CLARIFICATIONS TO THE VSIR 2014 AMENDMENT 3

Clarification No	001/2023	Date	22/03/2023
Distributor	All Distributors		
Clause No	7.5.2.5 PVC Service Pits		
Clarification/Intent/Ruling	Clarification		
<p>PVC service pits shall not be modified. This included creating additional apertures or shortening or increasing the pit depth.</p> <p>Drilling apertures in pits may attract the cost of a replacement pit.</p> <p>Ensure you contact the relevant Distributor prior to making any modification to underground pits.</p>

Figure 7.3-B UG Service Cables – Supply Connection Facility Requirements

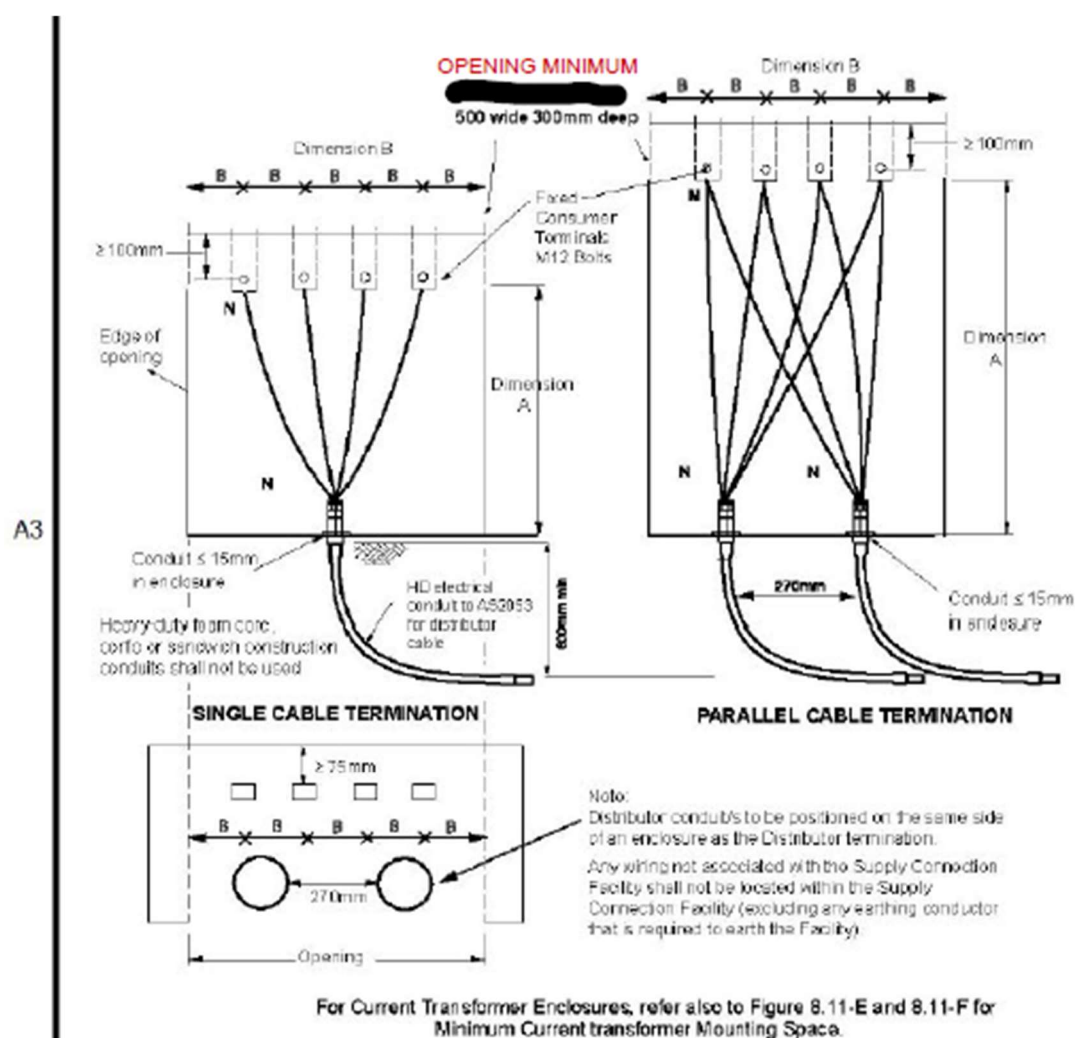
Clarification No	011/2023	Date	22/3/2023
Distributor	All Distributors		
Clause No	Figure 7.3-B		
Clarification/Intent/Ruling	Clarification

Clarification that the enclosure OPENING minimum is 500mm x 300mm

<p>Figure 7.3-C Typical FSD Termination Method</p> <p>Notes:</p> <ol style="list-style-type: none"> 1. Distribution Cables to terminate on bottom of FSD 2. Enclosure to meet requirements of AS/NZS 3439 or AS/NZS 61439

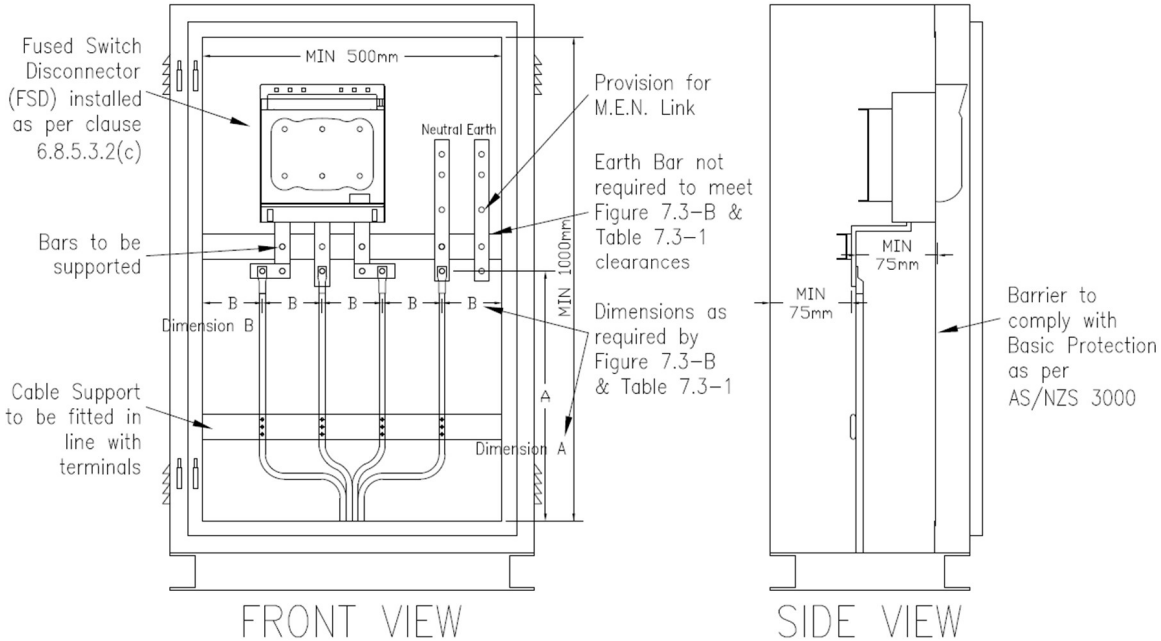
Clarification No	024/2023	Date	11/09/2023
Distributor	All Distributors		
Clause No	Fig 7.3-C		
Clarification/Intent/Ruling	Clarification		
<p>Clarification of Clearances.</p>  <p>The diagram illustrates the typical FSD termination method in two views: FRONT VIEW and SIDE VIEW. The FRONT VIEW shows a Fused Switch Disconnector (FSD) installed at the top, with a minimum clearance of 500mm above it. Below the FSD, there are bars to be supported, with a minimum clearance of 1000mm between the FSD and these bars. The bars are supported by cable supports fitted in line with the terminals. The distance between the bars is labeled as Dimension B. A Neutral Earth bar is also shown, with a provision for an M.E.N. Link. The Earth Bar is noted as not required to meet the clearances specified in Figure 7.3-B and Table 7.3-1. The dimensions for the bars and supports are as required by Figure 7.3-B and Table 7.3-1. The SIDE VIEW shows the FSD and the bars from a different perspective, with a minimum clearance of 75mm between the FSD and the bars. A barrier is shown to comply with Basic Protection as per AS/NZS 3000, with a minimum clearance of 75mm between the barrier and the FSD.</p>
